PR#: PR-50 and PR-52

TITLE: Performance-Based Emergency Core Cooling Systems Cladding
Acceptance Criteria

A Strange reference to Baker-Just

FIGURE 1: Measured Offset Strains

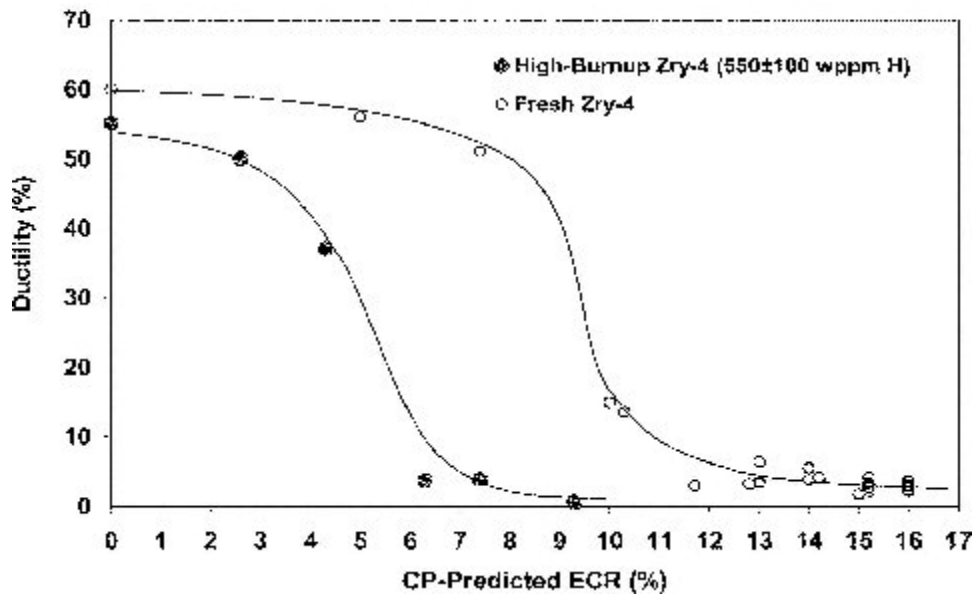
Furthermore, it is strange that only Cathcart-Pawel is used in Figure 1; there is no comparison with Baker-Just:
